**TOWN OF MOUNTAIN VILLAGE  
REGULAR DESIGN REVIEW BOARD MEETING  
AGENDA**

**THURSDAY FEBRUARY 4, 2021 10:00 AM**

**TO:** Mountain Village Design Review Board  
**FROM:** John Miller, Senior Planner  
**FOR:** Design Review Board Public Hearing; February 4, 2021  
**DATE:** January 22, 2021 (continued from January 7, 2021)  
**RE:** Staff Memo – Initial Architecture and Site Review (IASR) Lot BC513E

SHEET NUMBER:  
**A100**

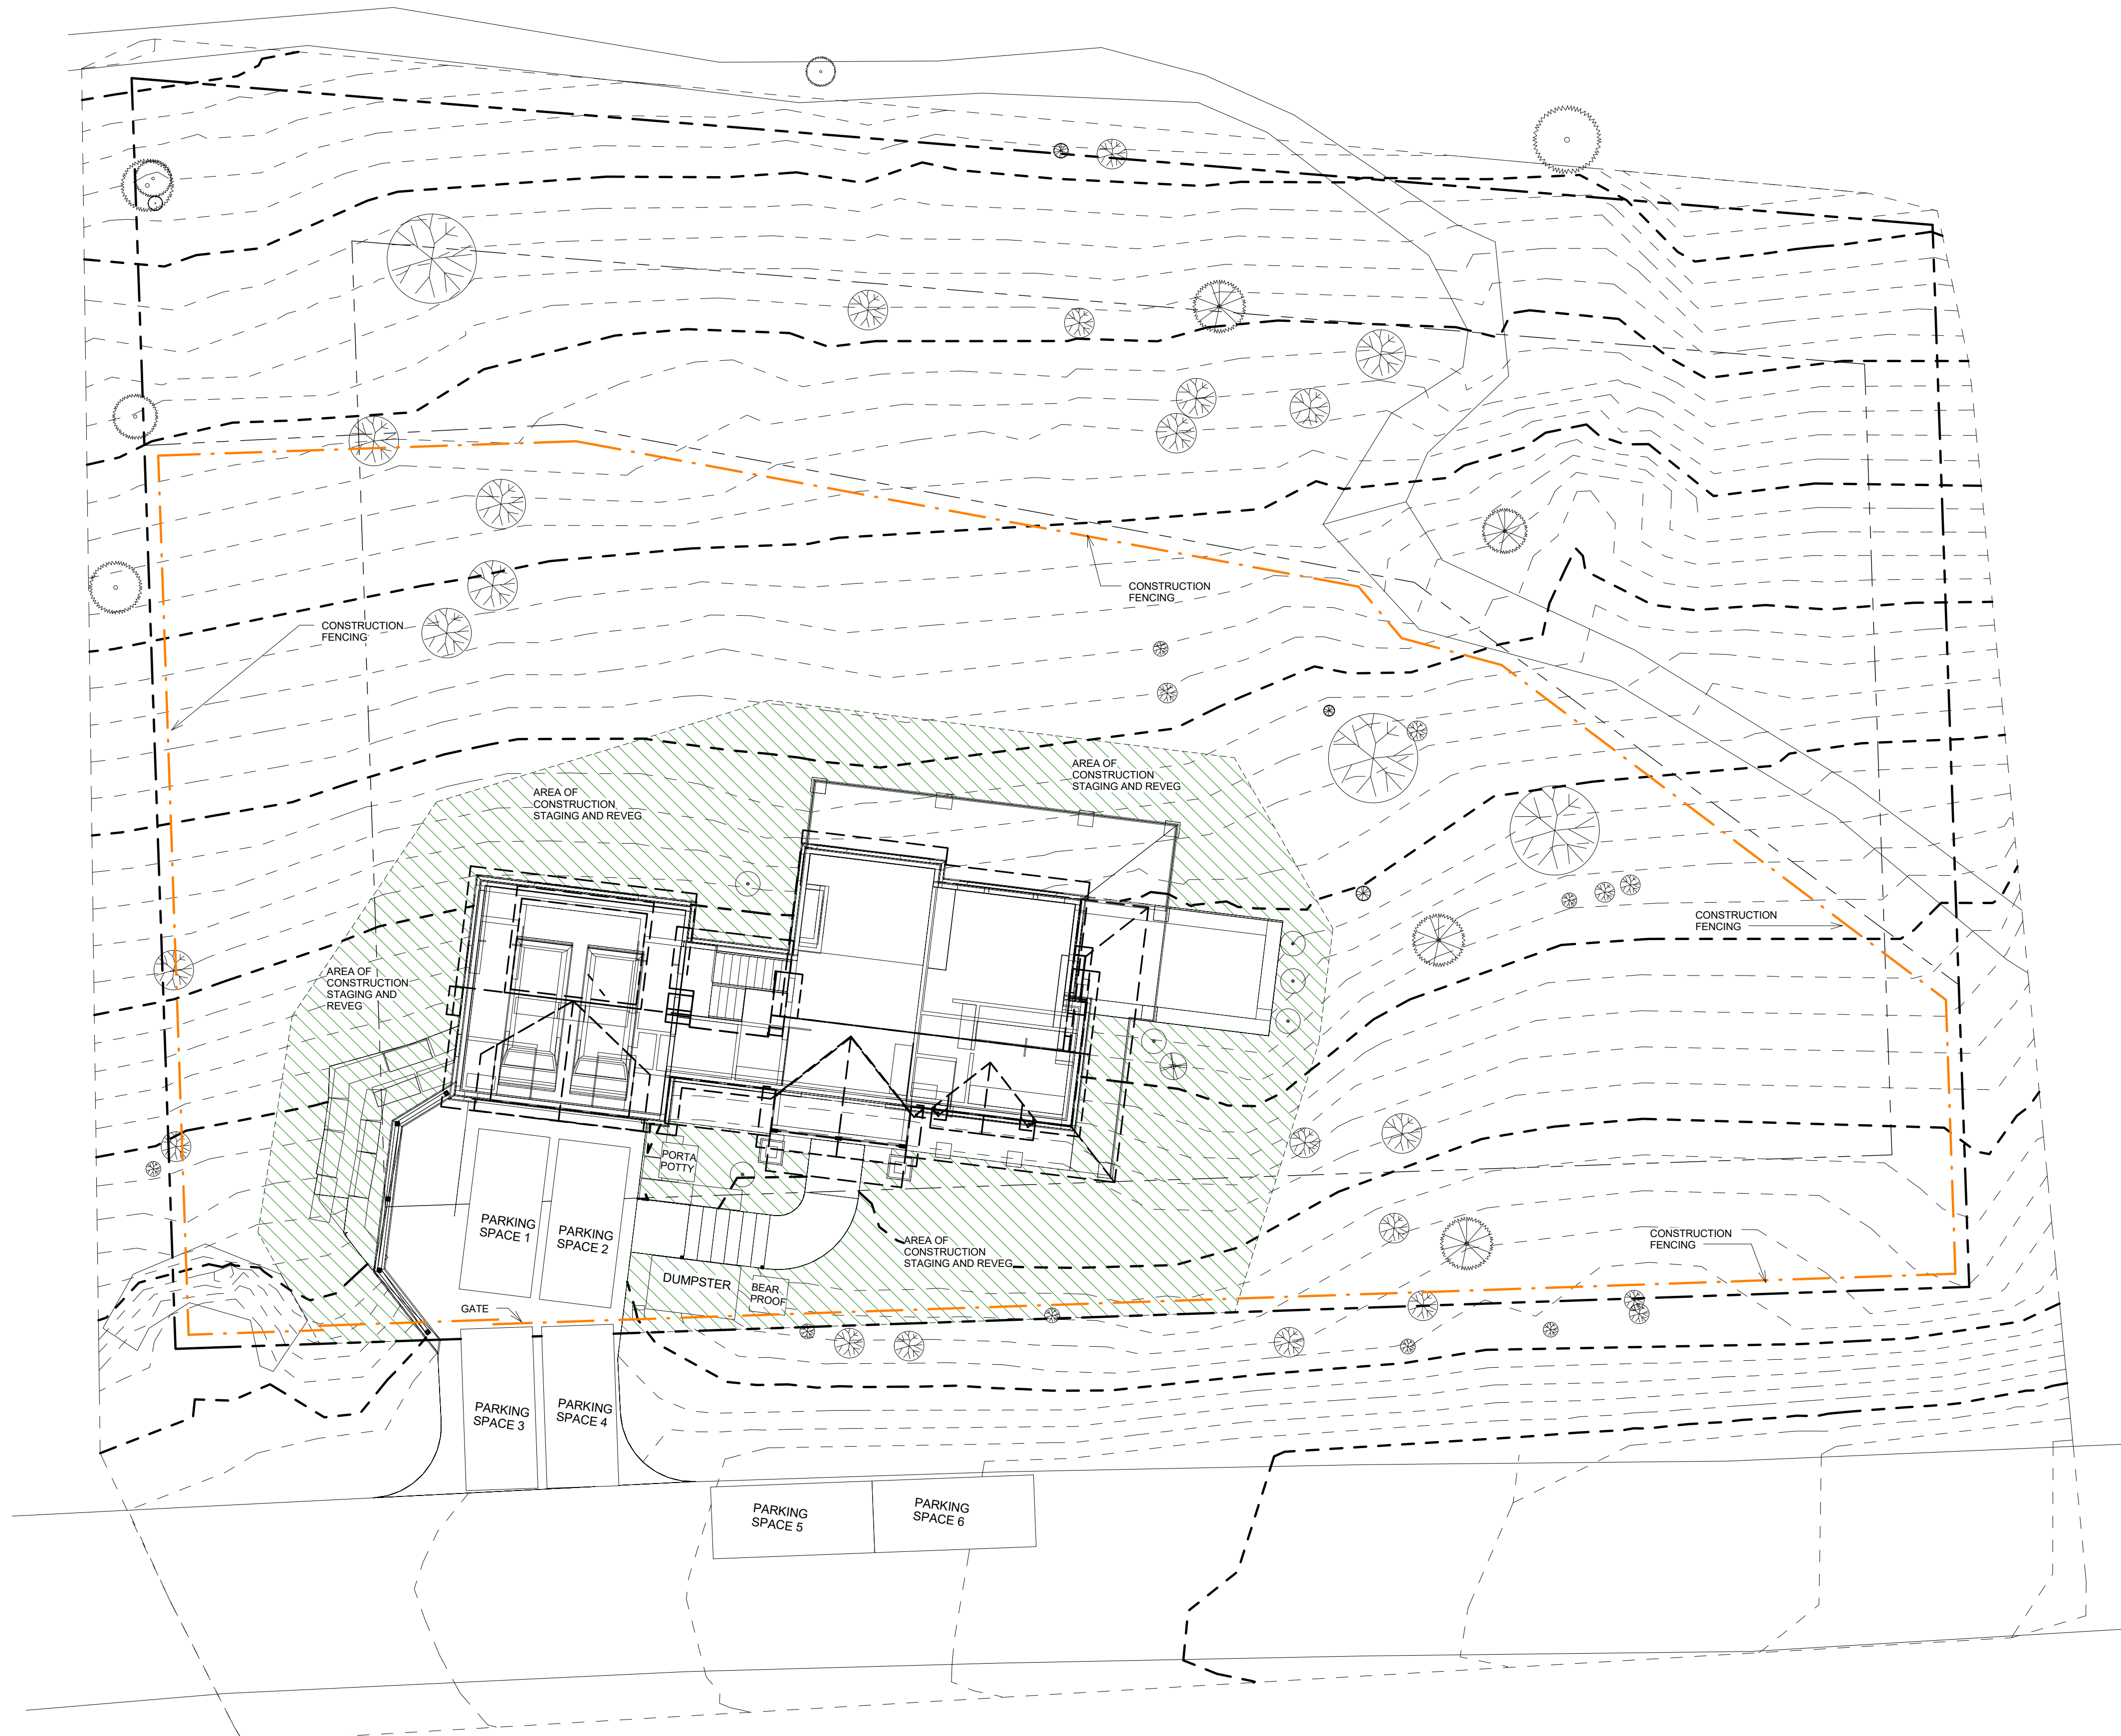
*There are also some discrepancies between page A100 of the plan and the grading and drainage design, specifically as it relates to the retaining walls throughout the site. Staff recommends revising the plans to demonstrate accurately both the locations and heights of these retaining walls prior to submittal for final review.*

- 1) Prior to submittal for Final Architectural Review, the applicant shall revise the site plan to specifically document the setbacks of the home to the property lines as well as any slopes over 30%.

- 2) Prior to submittal for Final Architectural Review, the applicant will revise the civil engineering plan set to driveway widths and retaining wall locations/heights to determine the full extent of encroachments into the GE.

PROJECT NAME: **LOT BC513E**  
MOUNTAIN VILLAGE, COLORADO 81435  
SHEET DESCRIPTION: **EXTERIOR LIGHTING PLAN**  
SHEET NUMBER: **A104**

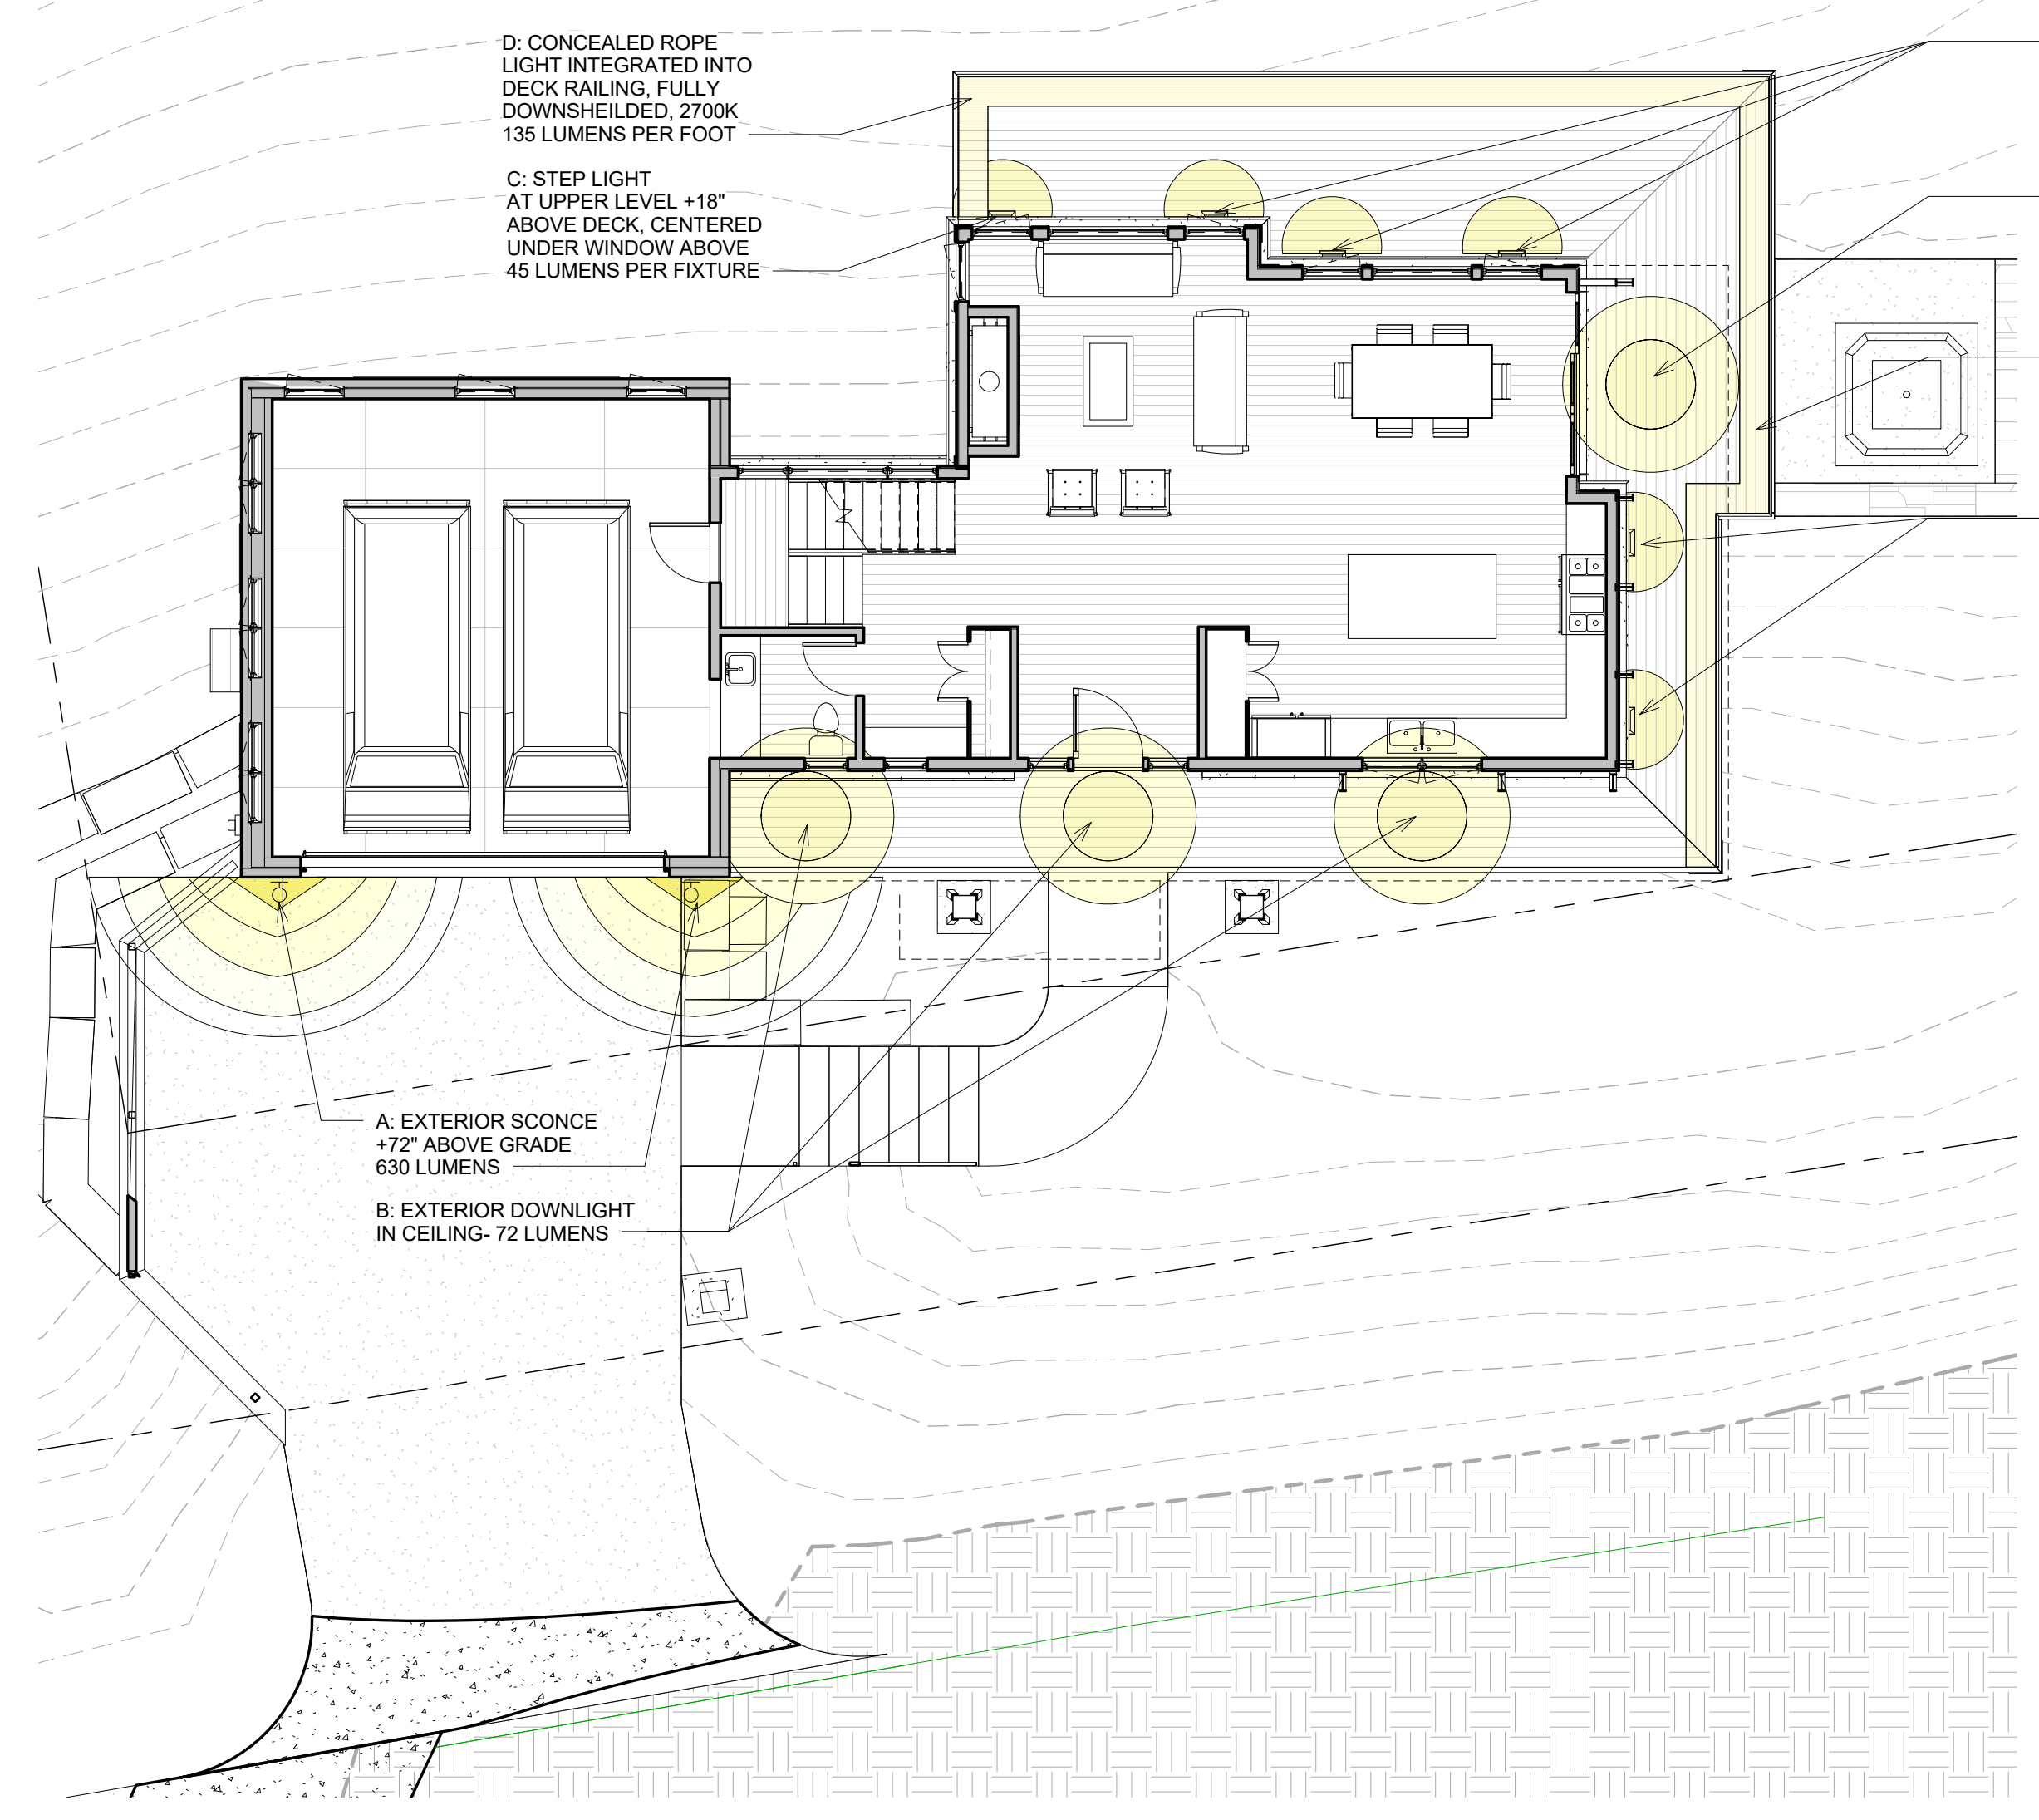
*Staff: The applicant has provided a preliminary lighting plan demonstrating the locations and types of fixtures at a very high level. The applicants have revised their lighting plan to remove the majority of the fixtures on the north side of the home, with the exception of the in-rail lighting which shall be shielded by a metal plating surrounding the porch area.*

*It should be noted the applicant has provided a photometric study of the home as required and that all fixtures proposed otherwise meet the illumination standards of the CDC. Cut sheets have been provided for two of the four proposed fixtures. The applicant shall provide a final lighting plan based on DRB comments.*
